COMMUNITY DEVELOPMENT DEPARTMENT REPORT

APPLICANT: Hawkins Companies

SUBJECT: H-2025-0007
Syringa Crossing Mixed-Use
Development (aka Hawkins Syringa
Crossing Subdivision) – AZ, CUP, PP

LOCATION: Generally located at the northwest and southwest corners of S. Meridian Rd./SH-69 & W. Amity Rd., in the SE 1/4 of Section 25, T.3N., R.1W and the NE 1/4 of Section 36, T.3N., R.1W.

FA3. Mixed Use Community Concept Color Diagram with Markup

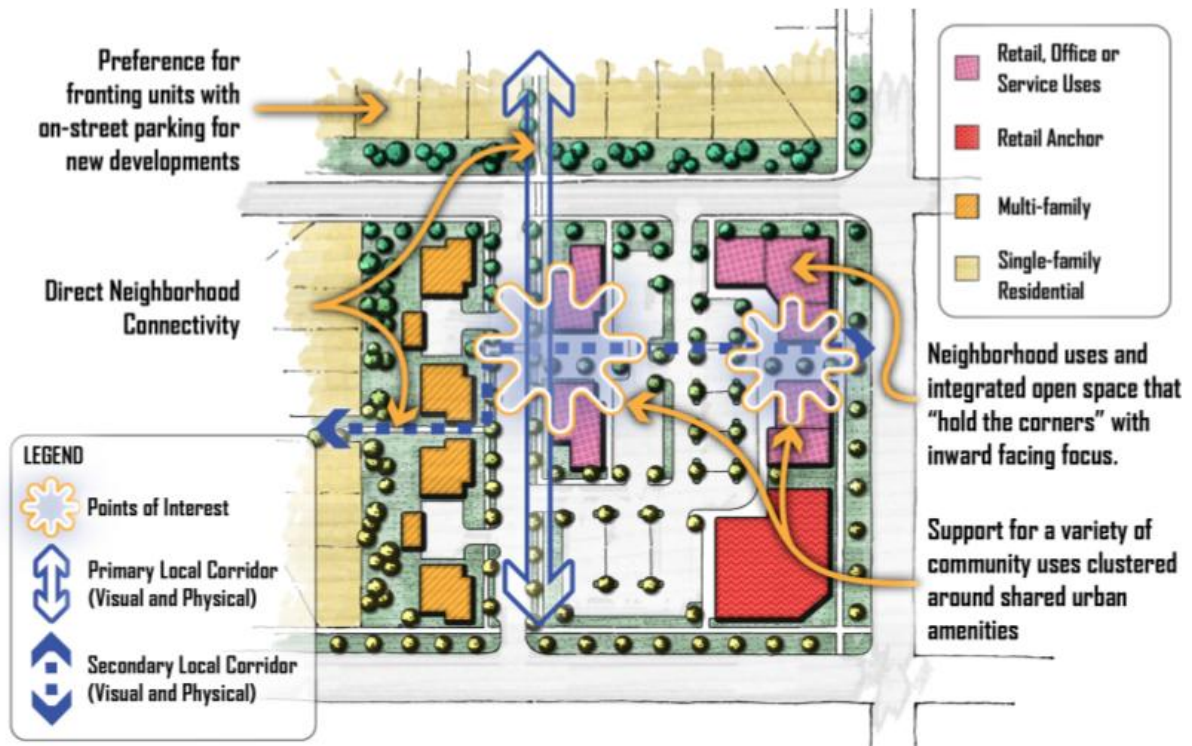
Non-residential buildings in these areas tend to be larger than in Mixed Use Neighborhood (MU-N) areas, but not as large as in Mixed Use Regional (MU-R) areas. Goods and services in these areas tend to be of the variety that people will mainly travel by car to but also walk or bike to (up to three or four miles). Employment opportunities for those living in and around the neighborhood are encouraged. Developments are encouraged to be designed according to the conceptual MU-C plan depicted in Figure 3E.

Development review for consistency with the Comprehensive Plan will consider the integration of use and holistic design sub-sections (below) in all mixed-use areas unless otherwise noted. To be successful, the principles outlined must be considered as interrelated features serving the basis of plan design. **Contiguous Mixed Use identified areas that are bisected by an arterial or highway are considered separate and independent areas for use and design integration and will be evaluated independently of each other per the Plan (pp. 3-14 & 3-16).**

iii. Block face

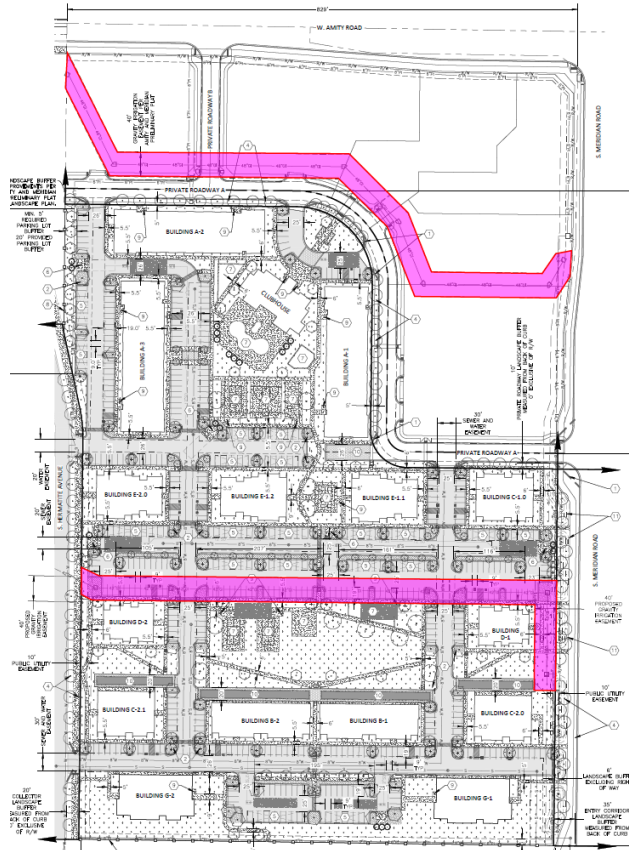
The proposed plat complies with the block face standards.
